**RE: PROPOSED YORK TRAVEL CENTER APPLICATIONS FOR SPECIAL USE PERMIT AND SITE PLAN APPROVAL, 0 MAIN STREET, TOWN OF YORK**

**RE: York Travel Center – SWPPP Review and Impact on Tax Parcel 61.-1-53.1**

LaBella has reviewed the Stormwater Pollution Prevention Plan for Construction Activity (SWPPP) at York Travel Center, prepared by Carmina Wood Morris, DPC, dated May 2021 and portions of the plan set, with the latest update March 18, 2022.

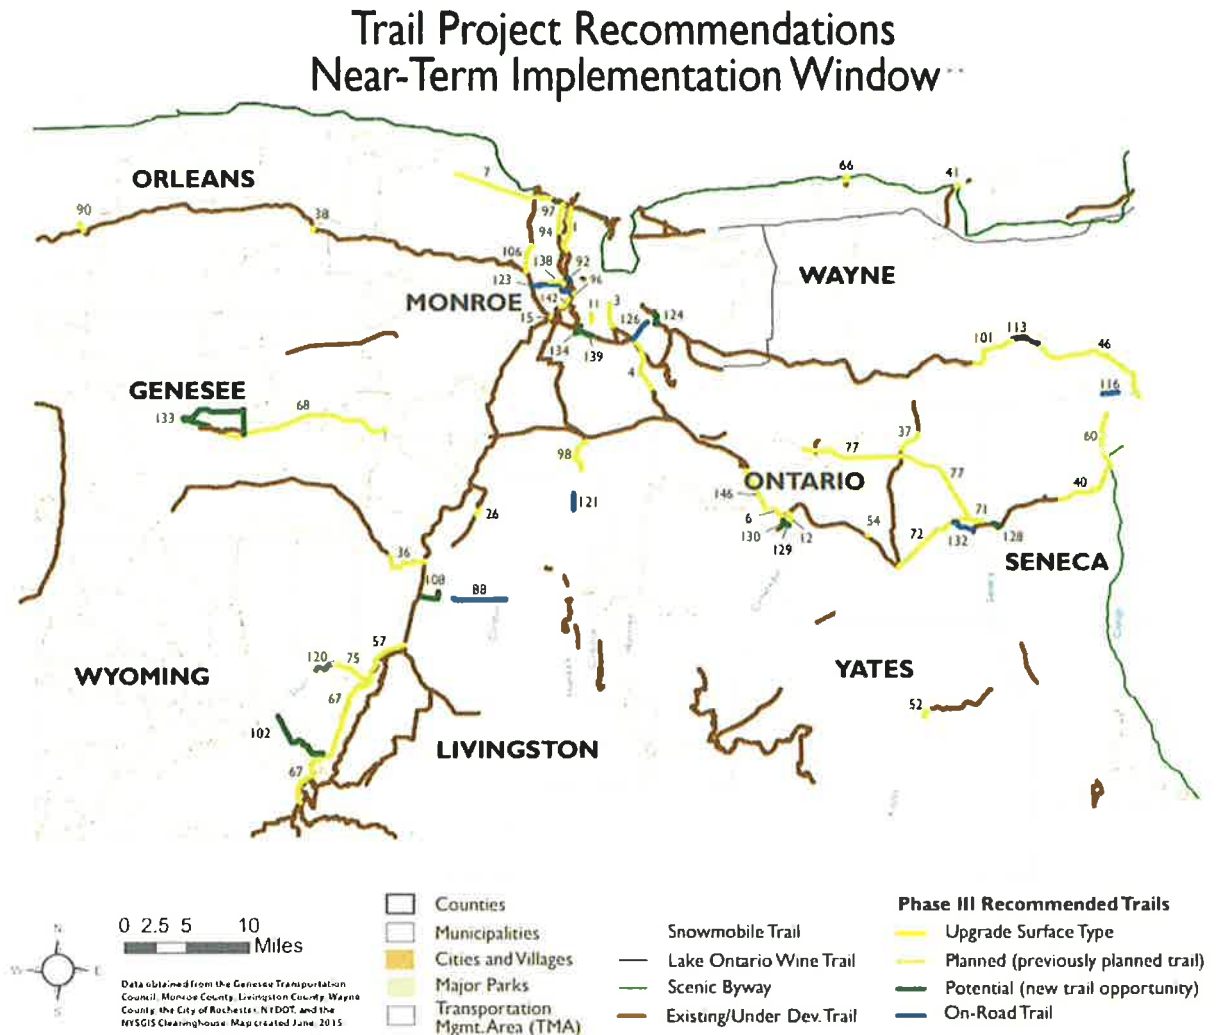
Below is a map from 2016<sup>7</sup> depicting a proposed trail over the property at segment 36:

Accordingly, the proposed project is inconsistent with the Town of York's comprehensive plan.
